SILVERADO RANCH FILING NO. 2

Construction Drawings El Paso County, Colorado

PCD File No. SF 246

**OVERALL SITE
PLAN**

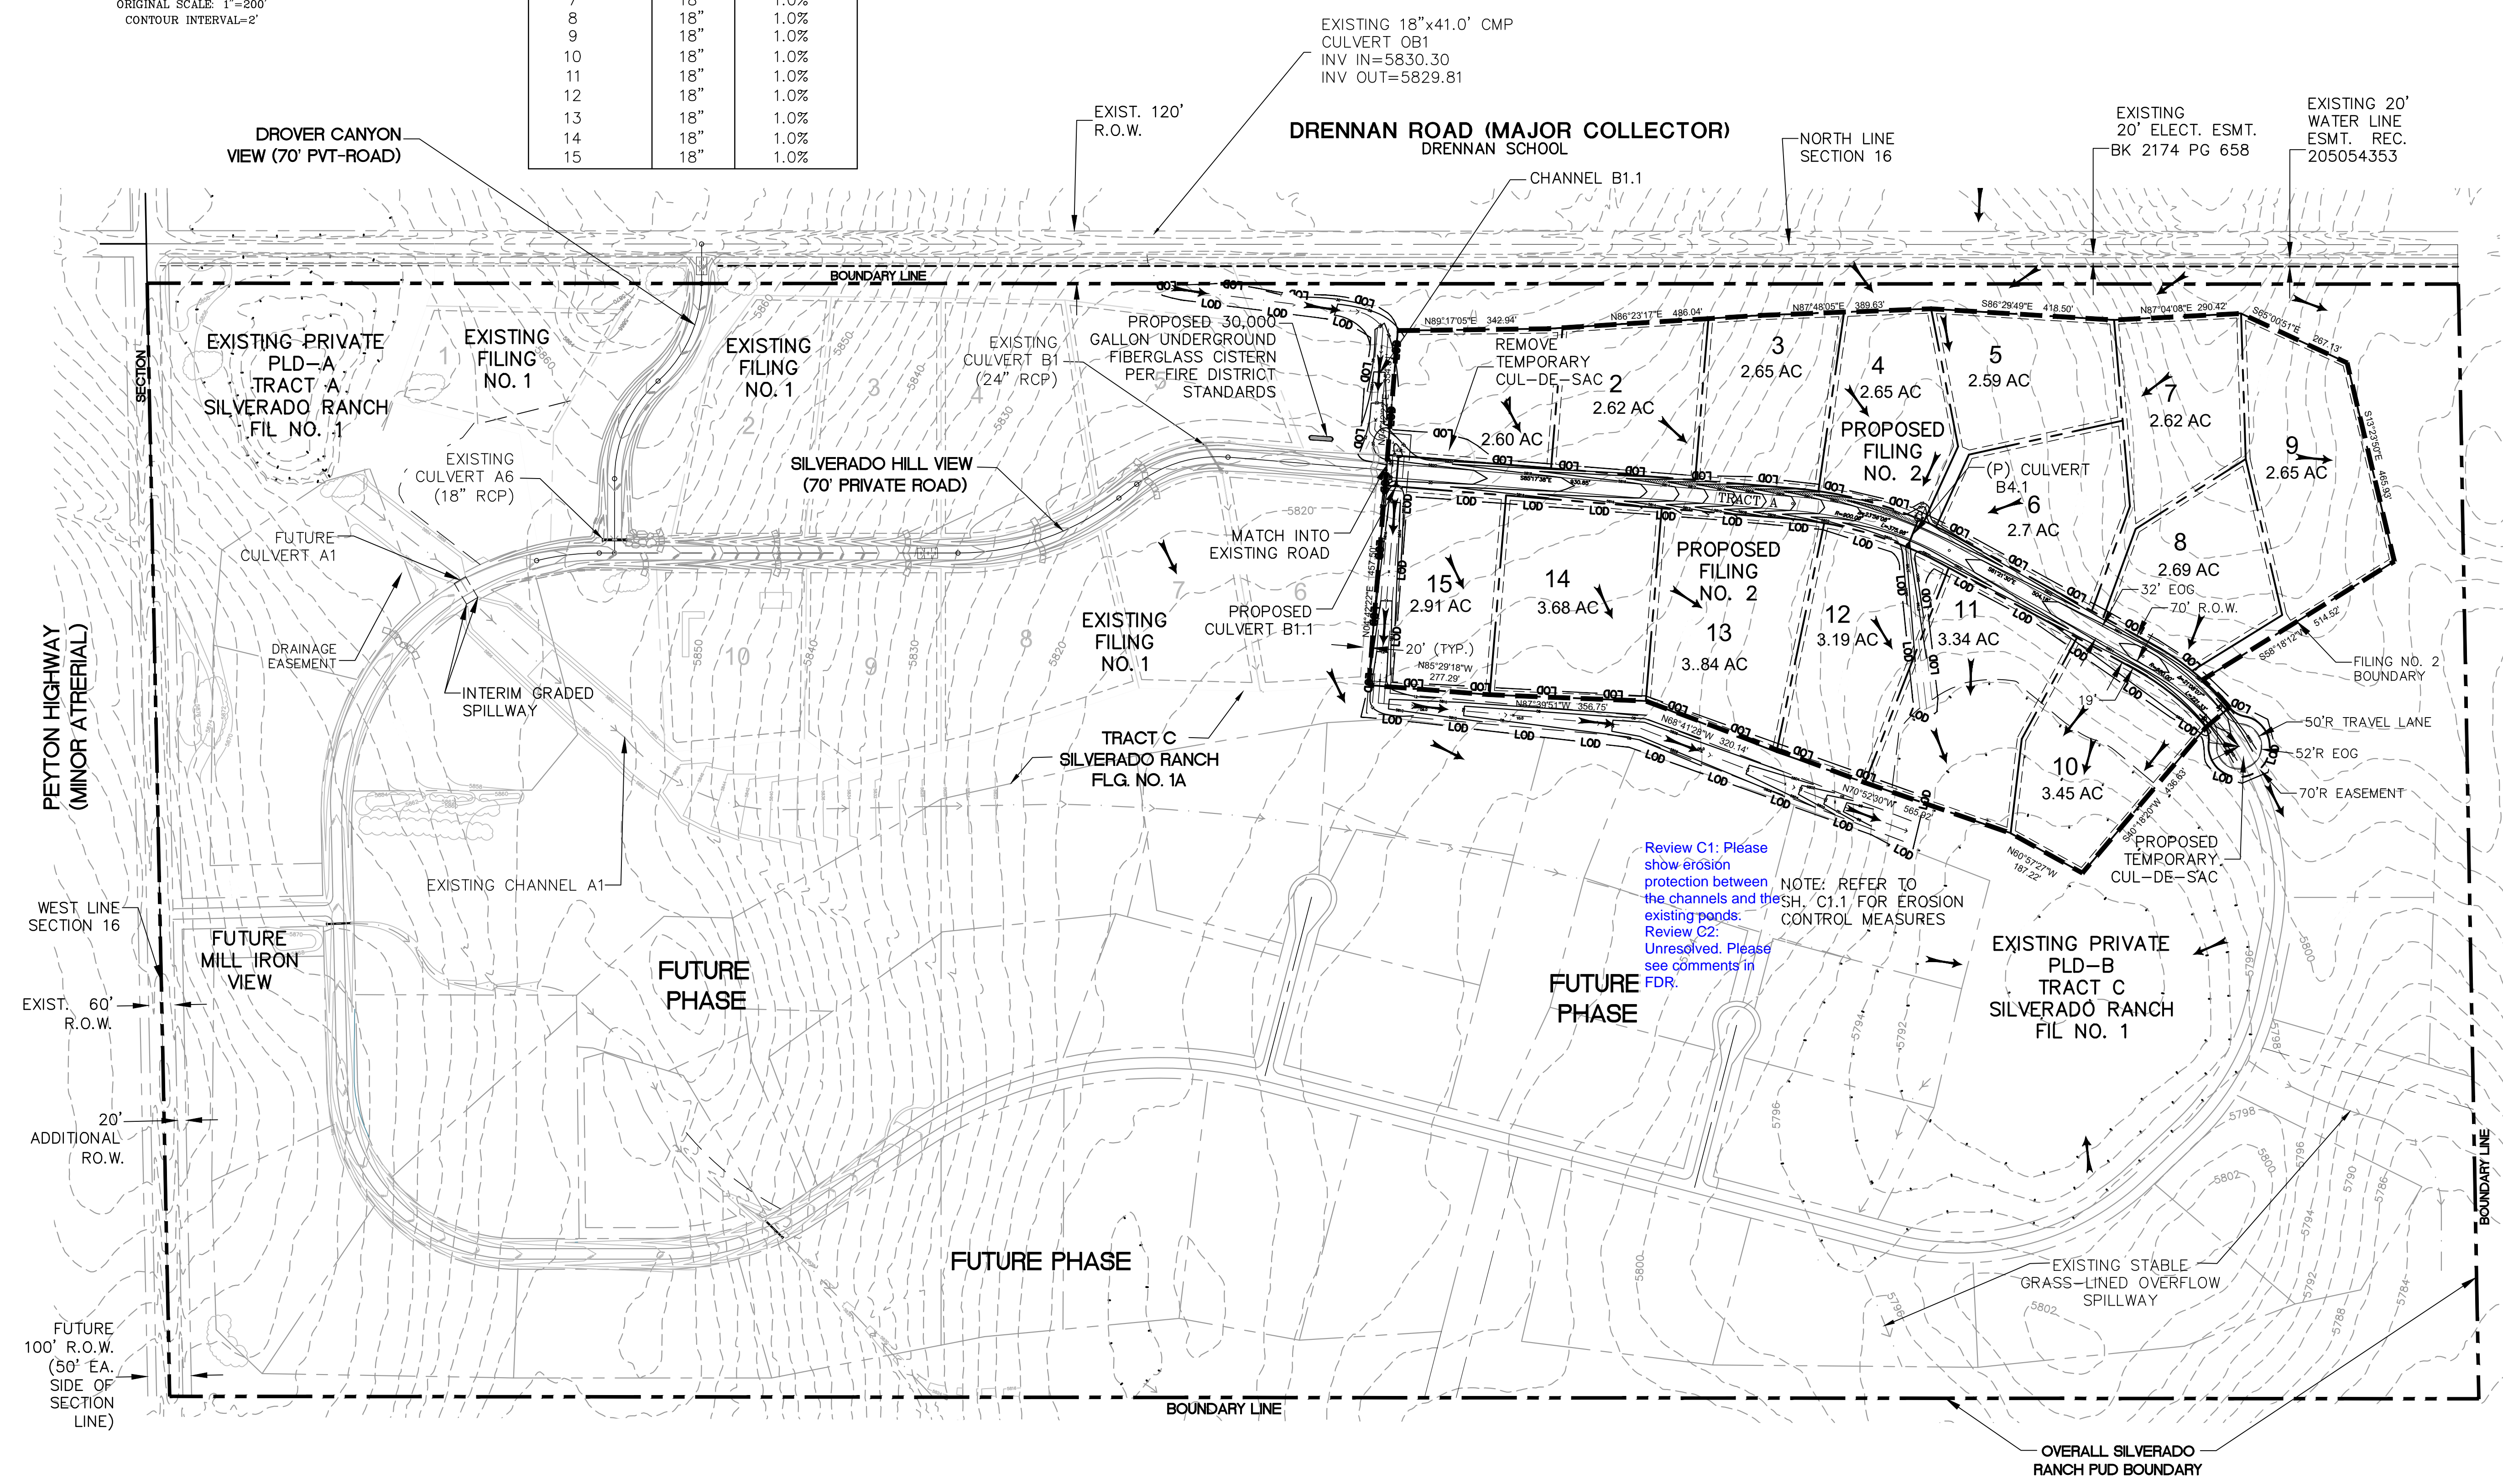
Review C1: Please show erosion protection between the channels and the existing ponds.
Review C2: Unresolved. Please see comments in FDR.
